ACCESSION NBR: 8710260347      DOC. DATE: 87/10/20      NOTARIZED: NO      DOCKET #  
 FACIL: 50-335 St. Lucie Plant, Unit 1, Florida Power & Light Co.      05000335  
 AUTH. NAME      AUTHOR AFFILIATION  
 WOODY, C. O.      Florida Power & Light Co.  
 RECIP. NAME      RECIPIENT AFFILIATION  
                                  Document Control Branch (Document Control Desk)

SUBJECT: Forwards response to 870820 request for addl info re 870612 application for amend to License DPR-67, authorizing replacement of spent fuel pool racks. W/nine proprietary oversize drawings. Encls withheld.

Re: St. Lucie Unit I  
Docket No. 50-335  
Spent Fuel Pool Rerack - Design and Analysis

RESPONSES TO NRC LETTER

TABLE 1

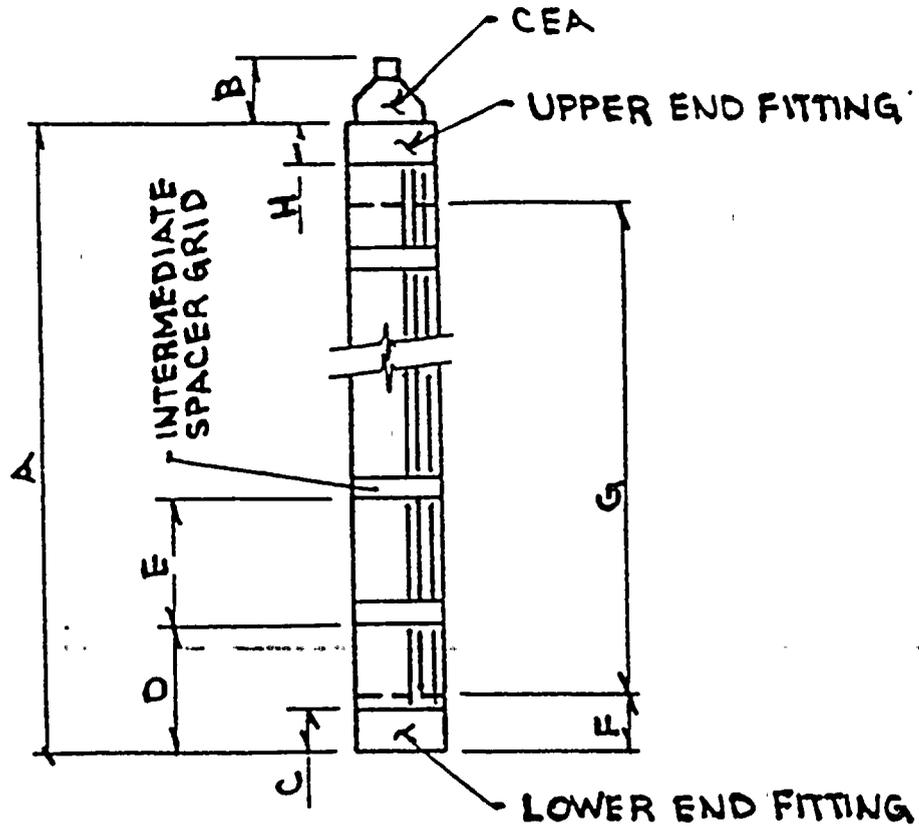
Question 1b - Provide a typical fuel assembly drawing indicating details of rack interface areas.

Response 1b - Attached Tables 1 and 2 present detailed information regarding the three types of fuel assemblies intended for storage in the new spent fuel racks. These fuel assemblies are shown in the St Lucie Unit 1 FSAR Figure 4.2-3, 18 and 19, and the St Lucie Unit 2 FSAR Figure 4.2-6. The assembly when stored in a spent fuel rack storage cell rests on the lower end fitting. During a seismic event, lateral contact between the fuel assembly and the storage cell wall may occur at one or more of the spacer grid assemblies. These items are shown in the figure included with Table 1.

REGION I FUEL RACK DESIGN

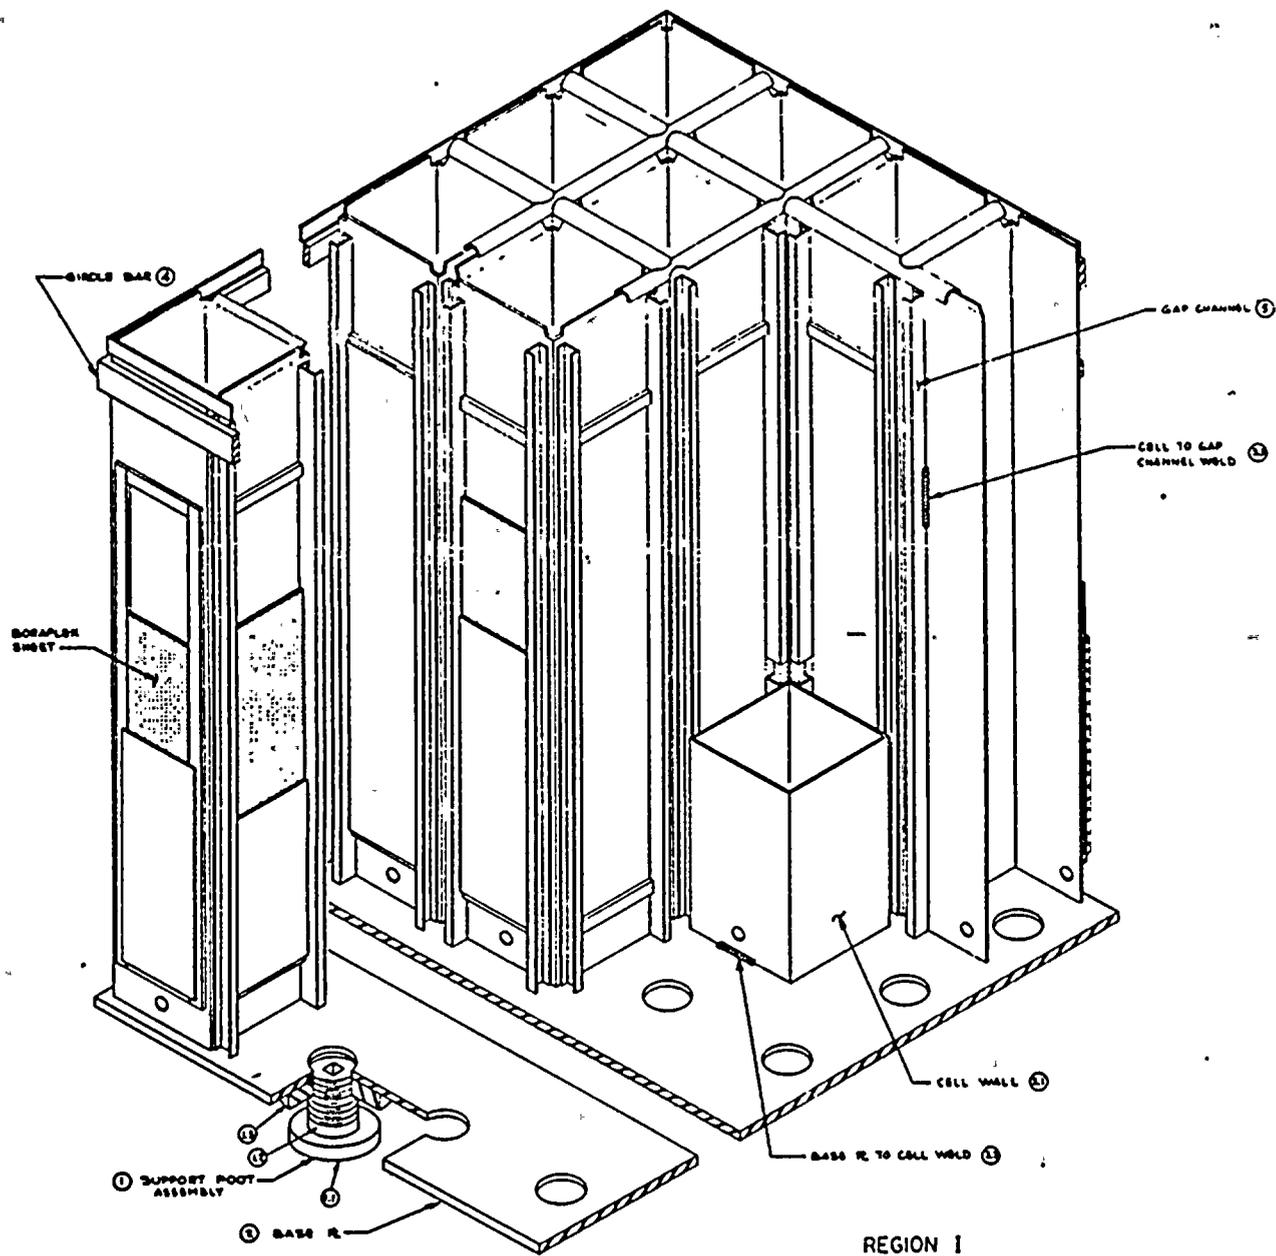
Question 1a - Provide typical fuel rack design drawings which indicate all weld details.

Response 1a - Region 1 and Region 2 fuel rack designs are represented pictorially in Figures JPE-LR-87-043-1 and JPE-LR-87-043-2. The attached Joseph Oat Corporation drawings, D-8286 Rev 1 and D-8288 Rev 1, show all design details for a typical fuel rack module.

FIGURE JPE-LR-87-043-3

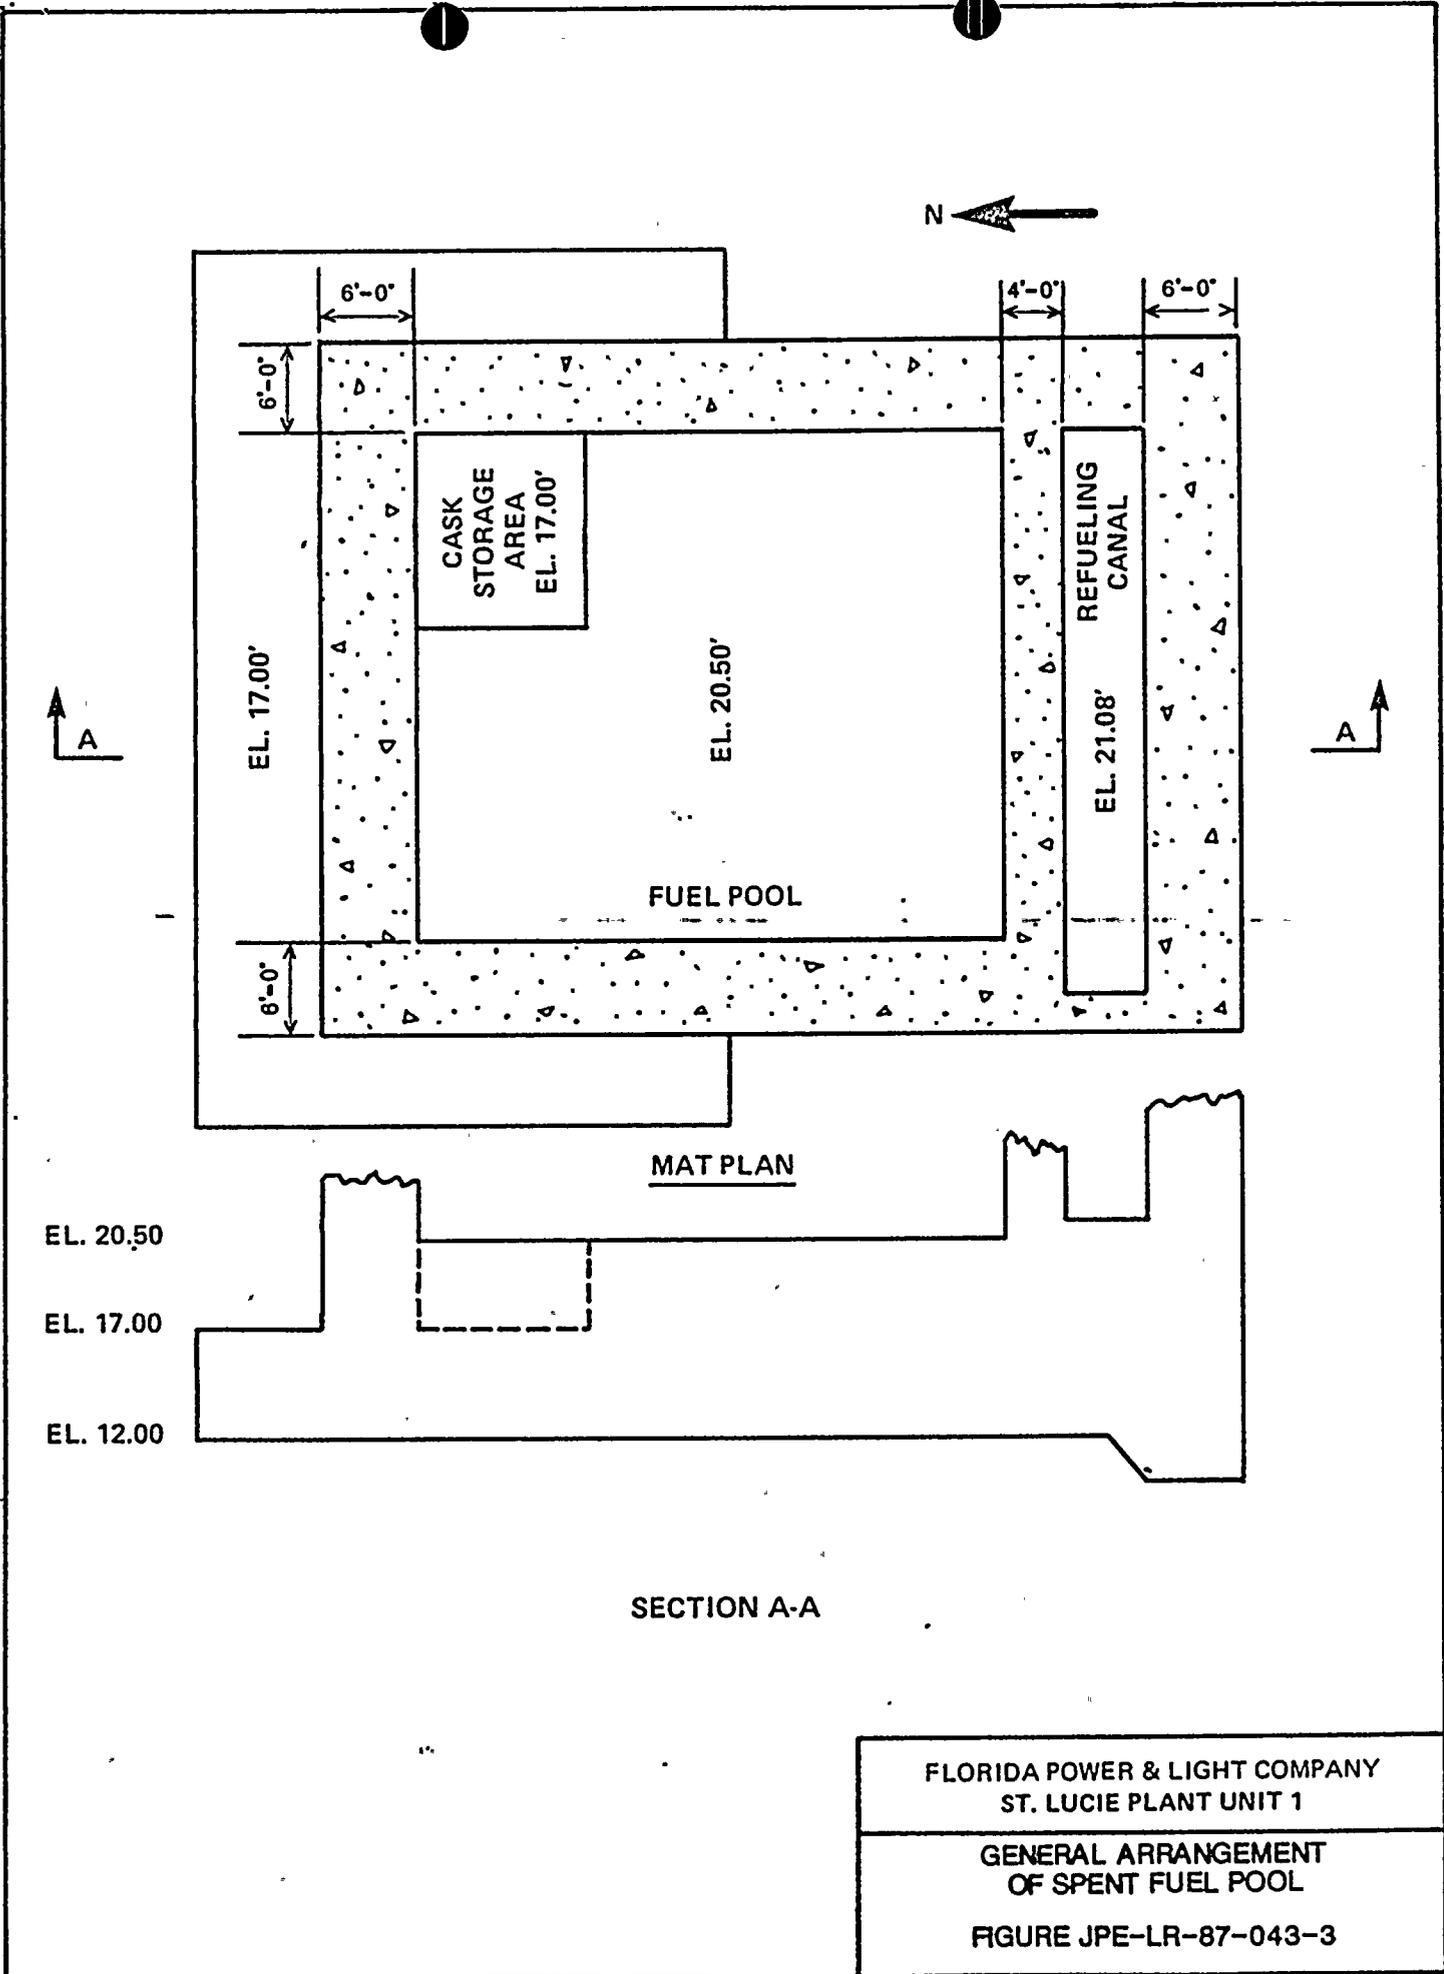
Question 1c - Provide detailed fuel pool drawings which show the liner weld seams, the leak detection system channels, and any modifications.

Response 1c - The attached Figure JPE-LR-87-043-3 shows the general arrangement and wall thickness of the spent fuel pool. The attached Ebasco Services Inc. drawings 8770-G-830 sheet 1 Rev 4, sheet 2 Rev 2 and sheet 3 Rev 4 show all the design details for the St Lucie Unit 1 spent fuel pool. Drawing 8770-G-830 sheet 4 Rev 0 shows 1-1/4 inch base plates which were added to the pool floor at the time of the last rerack.

FSAR FIGURE 3.7-9

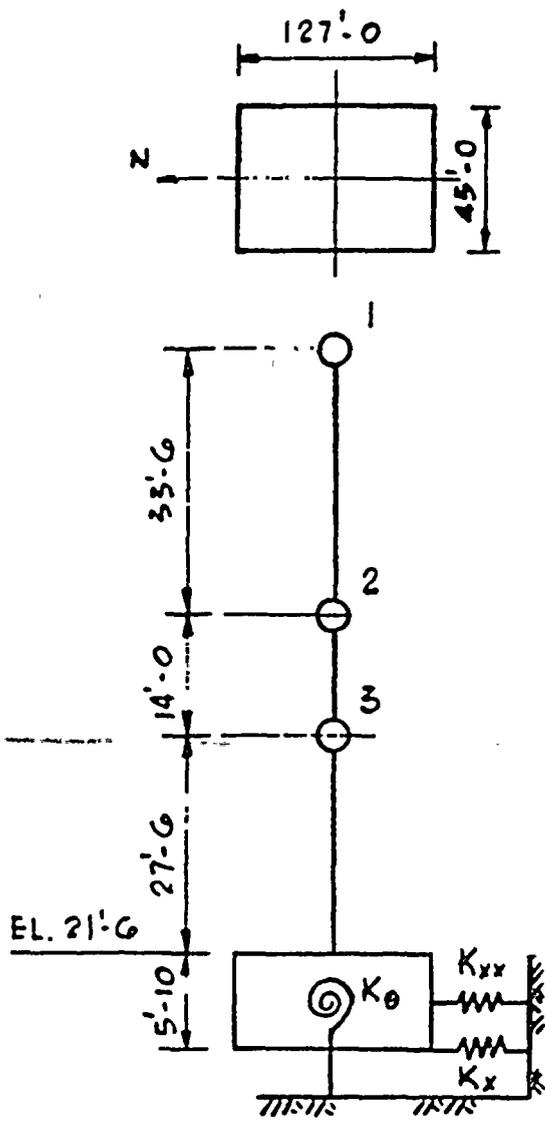
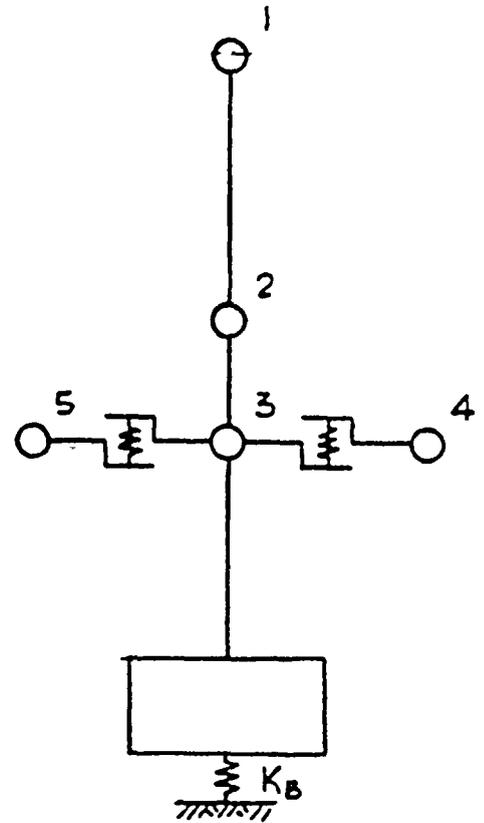
Question 2a - Provide a detailed description of the methodology and analytical models used to generate the new floor response spectra shown in Figure 4.9.

Response 2a - The analytical model of the Fuel Handling Building (St Lucie Unit 1 FSAR, Subsection 3.7.2.1.1(a) and Figure 3.7-9) is represented by a cantilever beam with masses lumped at selected elevations simulating weights of floors, walls, columns and major equipment. The cantilever beam connecting these lumped masses is assumed weightless and elastic representing the stiffness of the walls. The foundation mat supporting the cantilever beam is considered as a rigid body and is supported by rotational and translational springs simulating soil-structure interaction.

For the horizontal direction, two models were used corresponding to the N-S (long) and E-W (short) directions of the building. Each model consists of a cantilever beam with three lumped masses.

For the vertical direction, a mathematical model was developed using the same lumped mass principles. However, since the focus of interest for this case is the middle of a floor bay or at column-floor junctures, appendages representing floor bay behavior are added to the cantilever beam resulting in a more complex model.

FIGURE JPE-LR-87-043-4

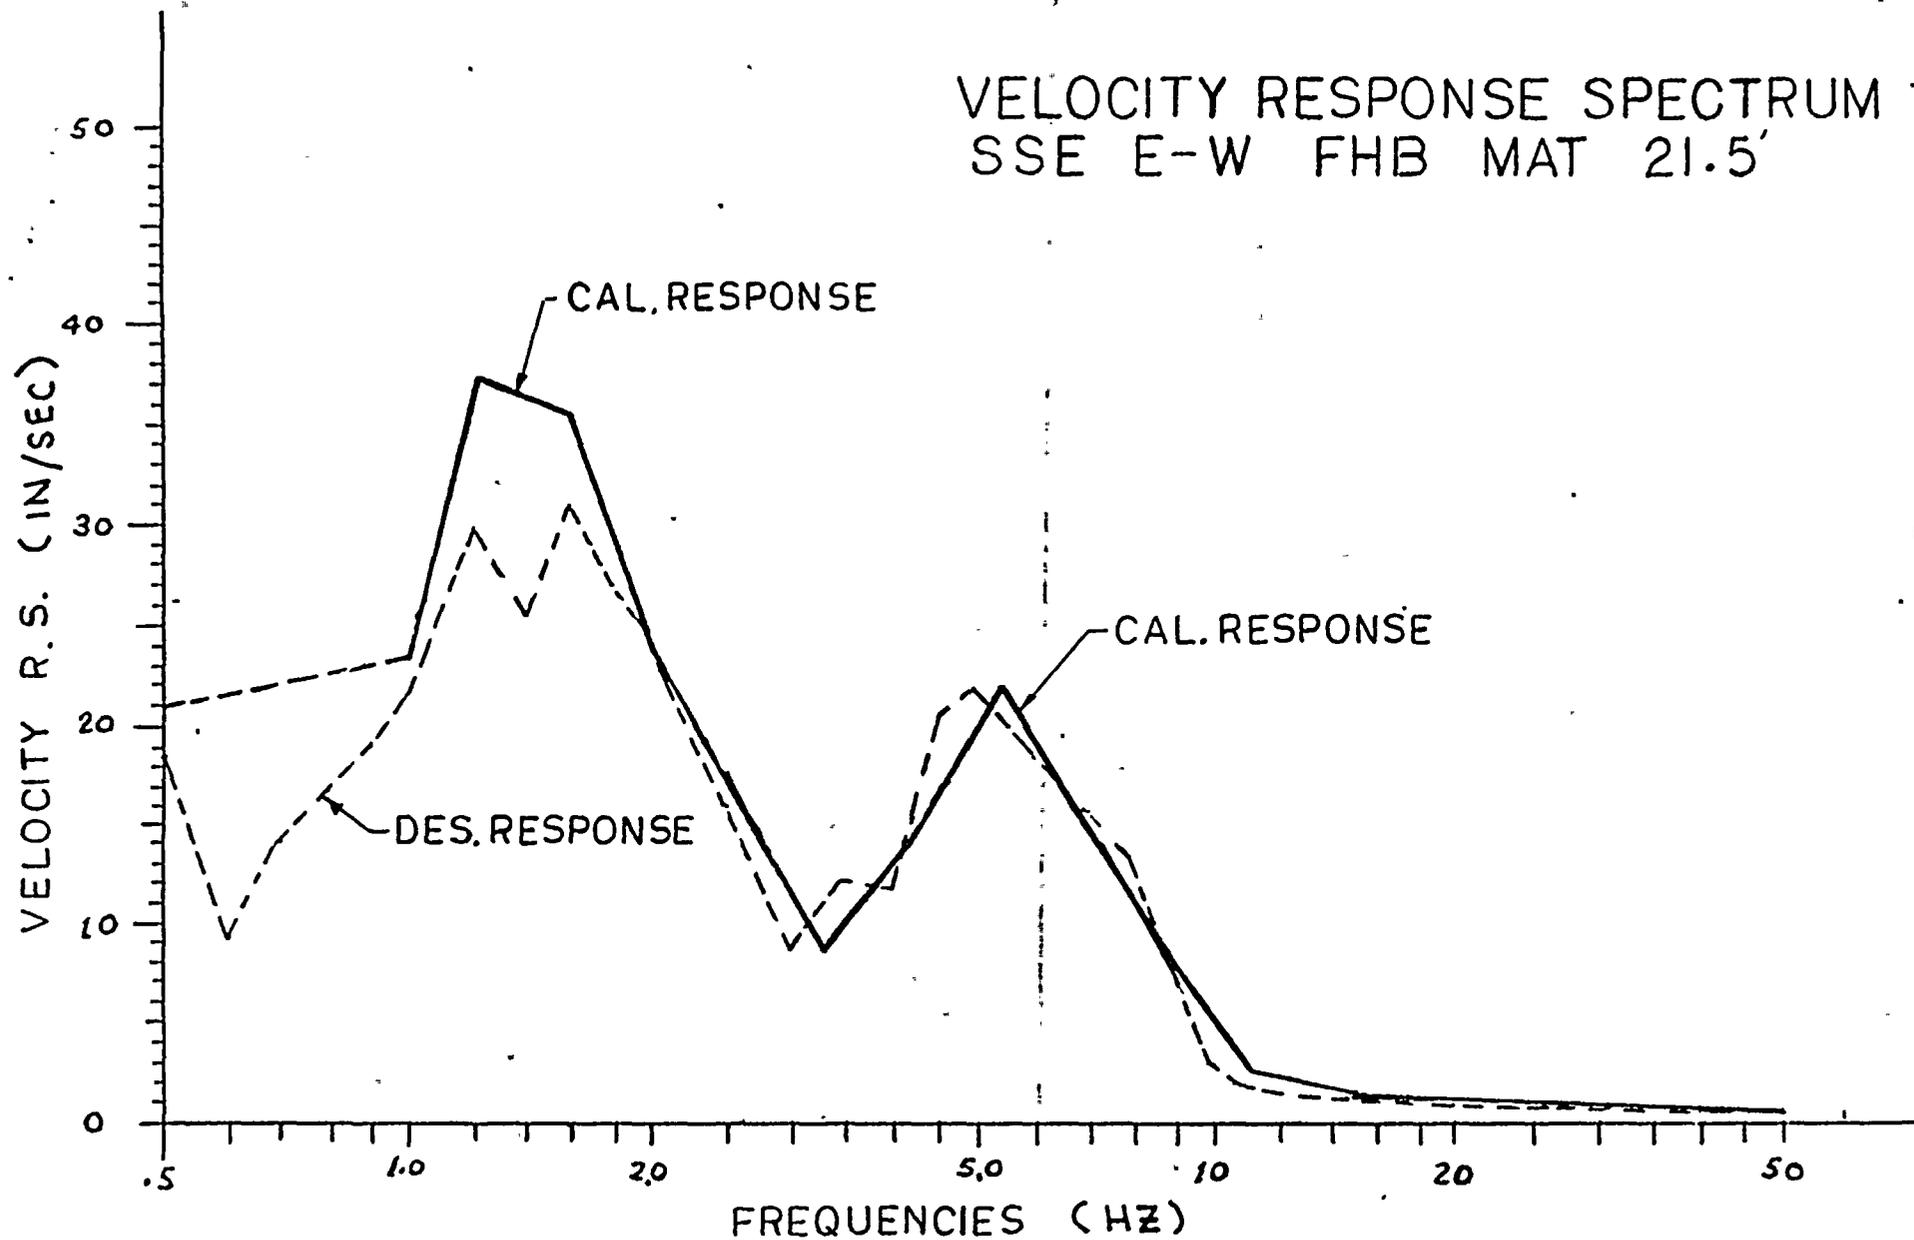
Question 2c - Provide a comparison of the response spectra for the pool floor motion shown in Figures 4-12, 13, 14, with the corresponding design response spectra of Figure 4-9.

Response 2c - The attached Figures JPE-LR-87-43-4, 5 and 6 provide a comparison of the design response spectra with the calculated response spectra corresponding to the artificially generated time histories. For clarity, velocity response spectra rather than acceleration response spectra are presented, as velocity spectra will accentuate the differences in the lower frequency range.

The plots demonstrate that the calculated curves closely envelope the design curves.
